# 1964 - 1966 Corvette: Service Bulletin: Gear Shift Control Assembly Buzz

**Bulletin No:** TSB #66-65

**Date:** June 13, 1966

FIGURE 1

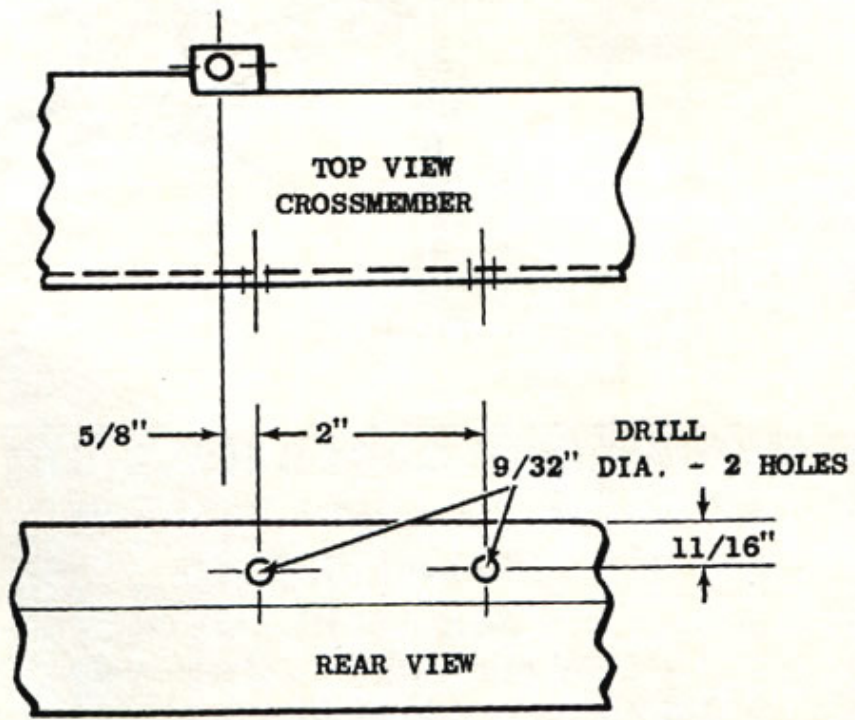
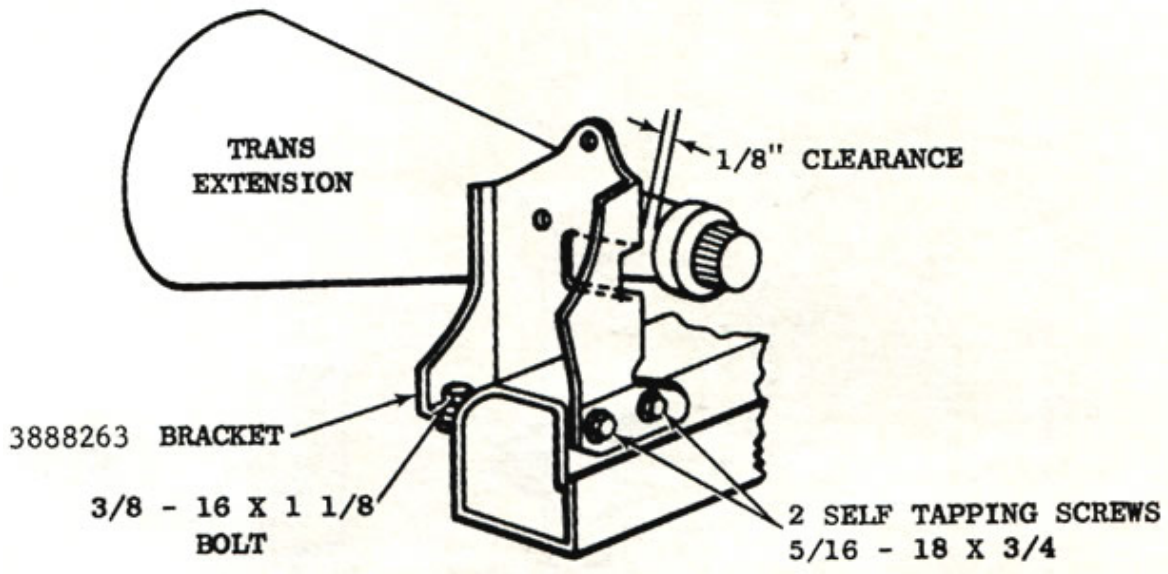
7. Scribe a line 11/16" down from top surface of crossmember on rear side (See fig. 1.)
8. Move new bracket, Part No. 3888263, into position from rear of crossmember.

9. Loosely install bolt through front leg of new bracket through mounting tab on front of crossmember (center in slot). (See fig. 2, item 6.)
10. Using bracket as template, locate position of holes to be drilled at center of bracket slots. (fig. 1)

11. Remove bracket and drill two 9/32" holes in rear of crossmember. (See fig. 1.)
12. Loosely install new bracket using two 5/16" self-tapping screws and washers at rear attachment. (See fig. 2, items 4 and 5.)

15. Reinstall transmission mounting assembly and bracket and exhaust support. Tighten all bolts securely with exception of bolt holding new bracket.
16. Adjust new bracket laterally to provide desired 1/8"\* clearance between transmission extension and bracket, then tighten bracket

screws securely. (See fig. 1.)

\* Clearance in excess of 1/8" may cause binding in reverse operation.

FIGURE 2

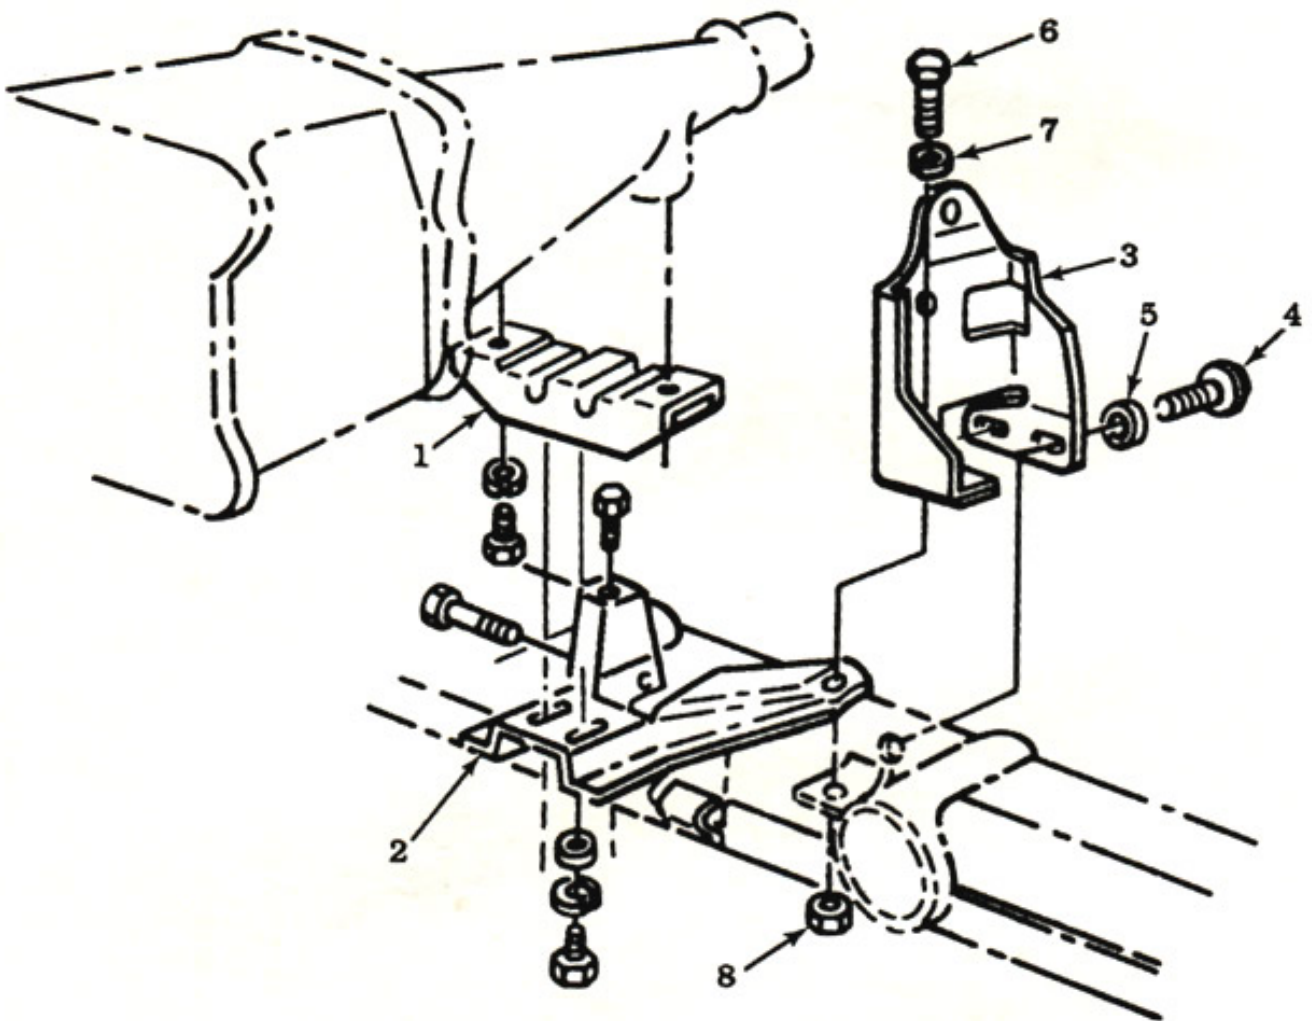
1. Remove shift levers at transmission.
2. Position jack stand under transmission and remove transmission mounting assembly and bracket. (See fig. 2, items 1 and 2.)
